Submissions Report

Moree Battery Energy Storage System

Moree Plains Shire LGA, Moree, NSW

September 2025

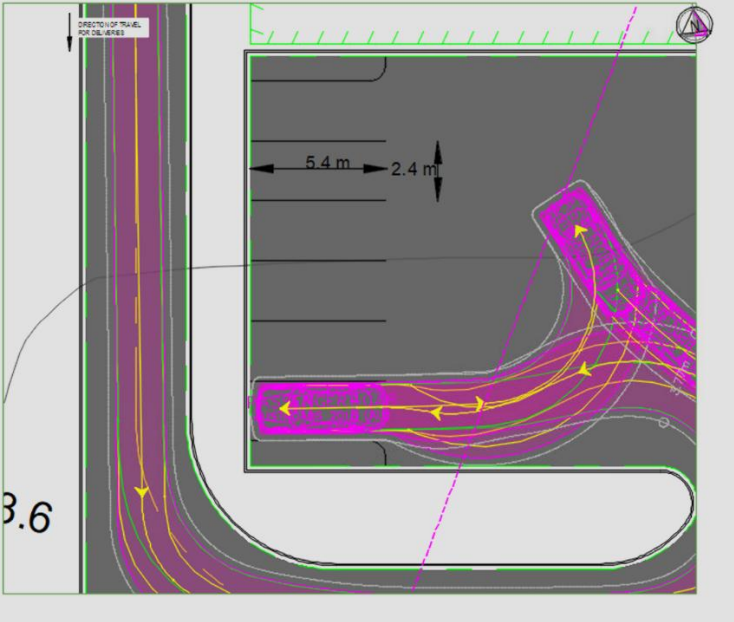
Submission	Response	Reference Location
	All vehicles will access and exit the site in a forward direction. Once operational, it is likely that the development will only need to be accessed by light vehicles for repairs and maintenance. Visitor carparking is not required given the nature of the proposed development; however, parking is provided for staff, contractors and others who would visit the site. The Applicant notes that the design attached within Appendix A of the SEE is for operations, not construction. As stated above, no large vehicles would be required operationally. All internal roads would comply with the relevant standards.	
Parking requirements		
The development proposes 5 parking spots for a B99 vehicle. It is unclear if this will be enough parking spaces for future employees. The traffic impact assessment report does state that the proposed parking spaces will be sufficient to cater for the development, although it is unclear if larger vehicles would be required to access the development for parking. The proposed parking spaces do not show the dimensions. As per DCP, the dimensions for 90 degrees parking spaces are to be 5.4m long by 2.5-2.7m wide. As per AS2890.1, for employee and commuter parking, dimensions are 5.4m x 2.4m.	As stated above, five parking spaces are proposed for the development. The Applicant confirms that five parking spaces is considered more than adequate for the operation of the proposed BESS During the operational phase of the proposal, only 1-2 maintenance personnel are expected, likely to access the proposal by light vehicles for repairs and maintenance (as detailed above). Parking for larger vehicles are not required. An updated plan detailing parking space dimensions is provided in Figure 4-1 below.

Submission	Response	Reference Location
	 Figure 4-1 Car parking space dimensions	
Drainage		
The proposed treatment train has been modelled using MUSIC software whereby the results conclude that all of the required pollutant targets are achieved except for the total nitrogen reduction target. The proposed development must ensure compliance with all of Council's pollutant targets.	Two scenarios have been developed to recommendations to how stormwater quality is to be managed and what infrastructure is required to meet the stormwater quality	Section 3.2.3 of this report and C.3
